REMARKS

This paper is being submitted in response to the Office Action of September 14, 2004.

AMENDMENTS TO THE DRAWINGS

FIG. 1

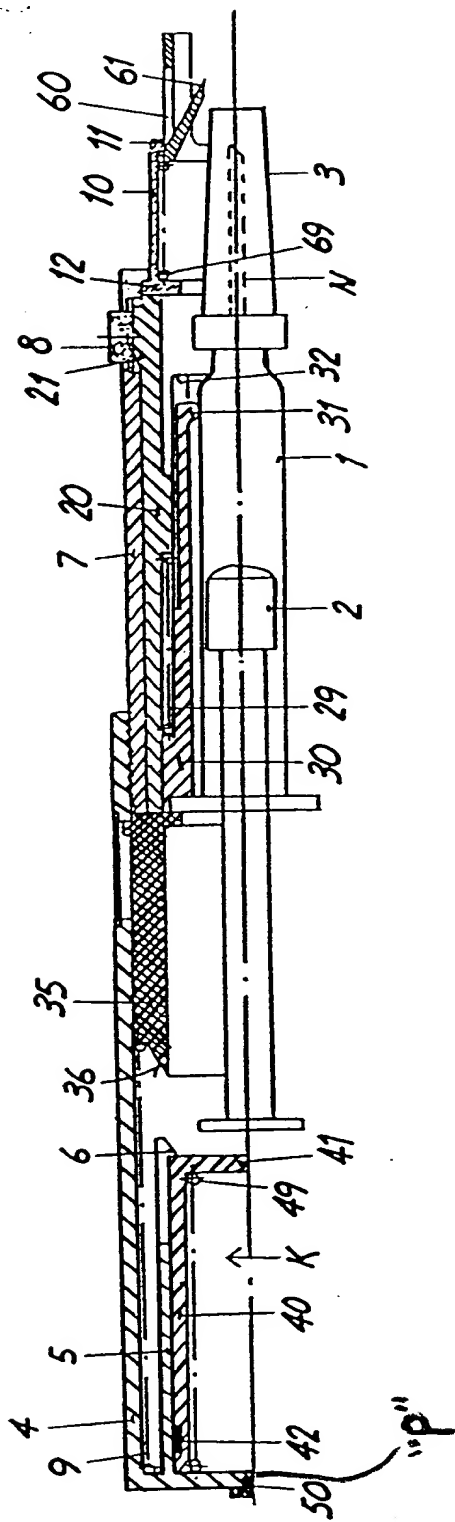
In the Action, the Examiner withdrew claims 5-10, 12 and 13 from consideration due to an election. She objected to the drawings and claims for failure of the drawings to show every claimed feature, and to the specification for failure to provide antecedent basis for claim recitations. Claims 1-4 and 11 were rejected under 35 USC § 102(b) as anticipated by Castellano et al. (US 5,536,249), Knauer (US 5,514,097), Haber et al. (US 5,320,609) and Rex et al. (US 4,592,745).

As to the Examiner's objections to claims 1 and 3, the drive element 49, e.g., a spring, is positively recited and applies the drive force on the driven member when the drive unit is actuated. (See, e.g., Figure 1 and the specification at page 13, lines 1-2, and 9-11.) The Examiner's comment regarding claim 3 has been taken into account, whereby the specification and drawings have been amended to reflect the disclosure of the originally filed claims and that the term "chamber port is intended to be generally synonymous with the passage "P" depicted in amended Figure 1.

Corrected drawings accompany this paper. The recited base section is generally synonymous with the housing sleeves 4, 7 which are shown in the originally filed drawings. The means for generating a damping force are depicted in the originally filed drawings, recited in the originally filed claims, and described in the specification at least at pages 13, line 14 *et seq.*, page 3, lines 9-14, and page 4, line 4 through page 5, line 10. The chamber port is generally synonymous with the passage depicted in Figure 1 and now labeled "P". Figures 1a and 1b, added for clarity, are taken from Figure 1 and are supported in the specification at least at page 14, line 3-7.

The attached sheets of drawings reflect a change in Fig. 1, i.e., the addition of "P" to designate the passage, and the addition of Figs. 1a and 1b which are views of features shown in the originally filed drawings and/or described in the specification. No new matter is added.
